Hallsville School District

All Purpose Field & Parking Lot Primary School Classroom Addition Secure Entry Doors

Progress Report #1

SUPPLEMENTAL INSTRUCTION 1 (SI 1)

SHEET
C302

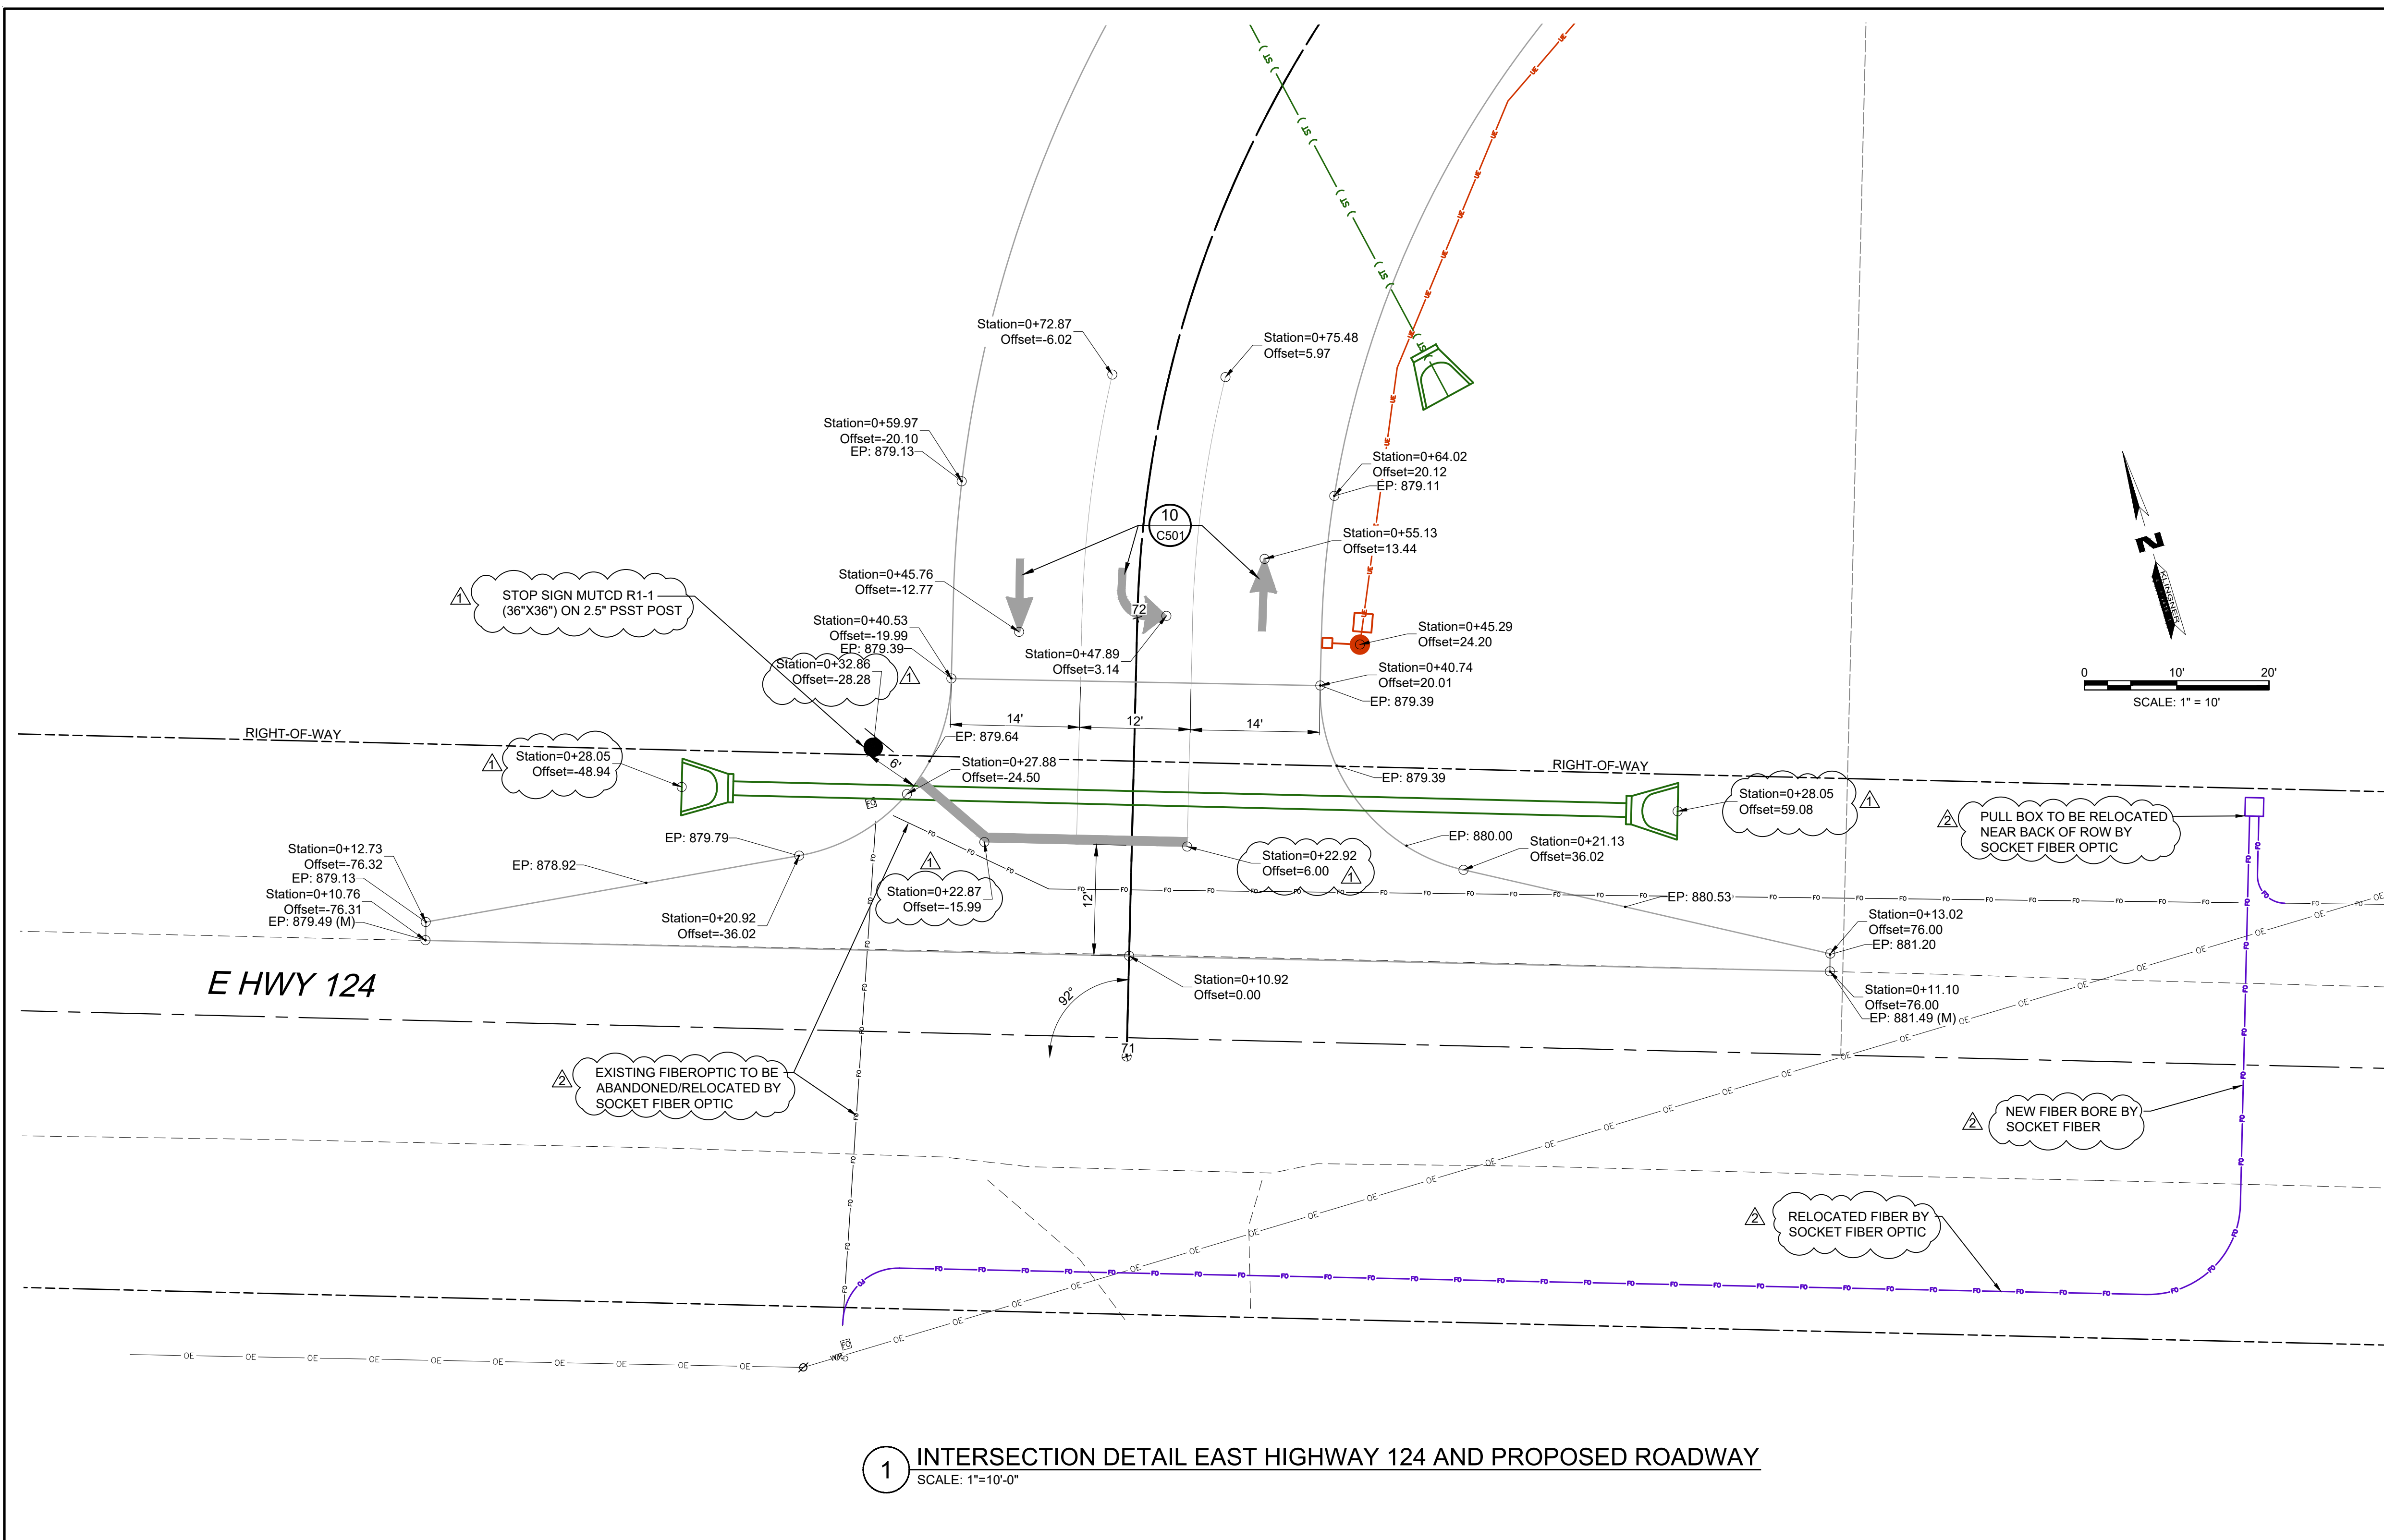
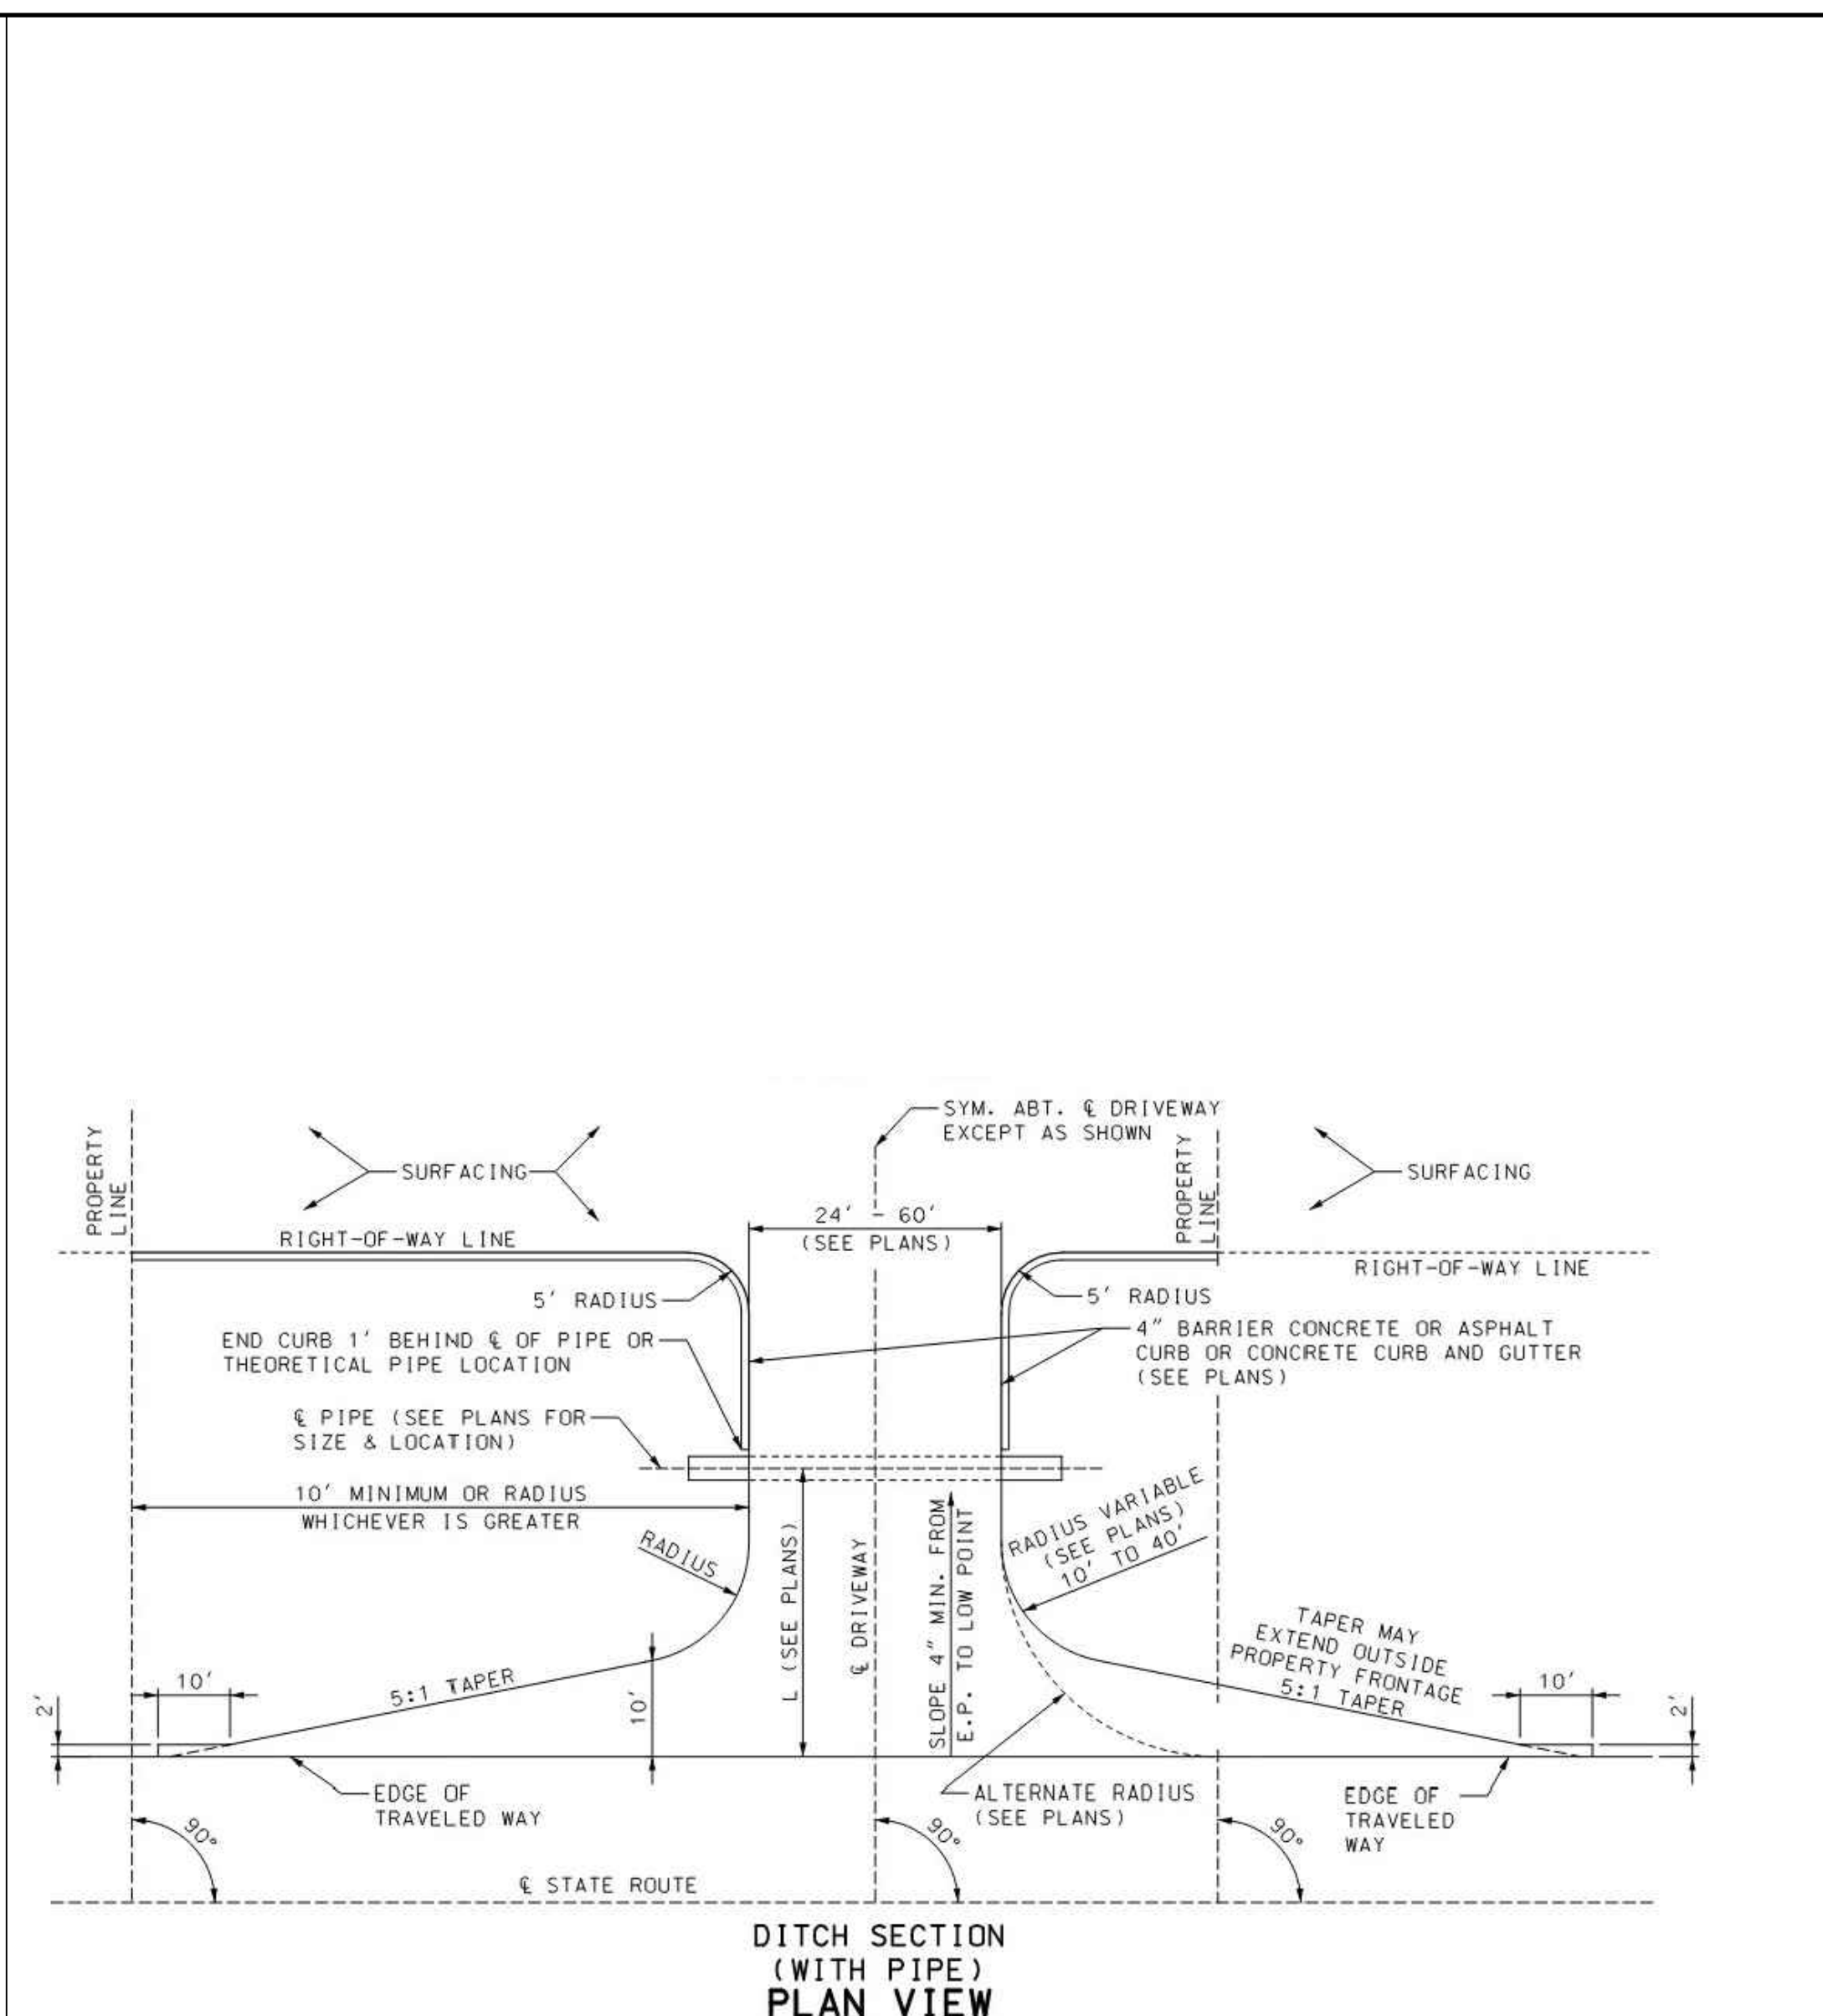
| 6 | Sheet C302 | Changed Flowline elevations and added fiberoptic relocation. |
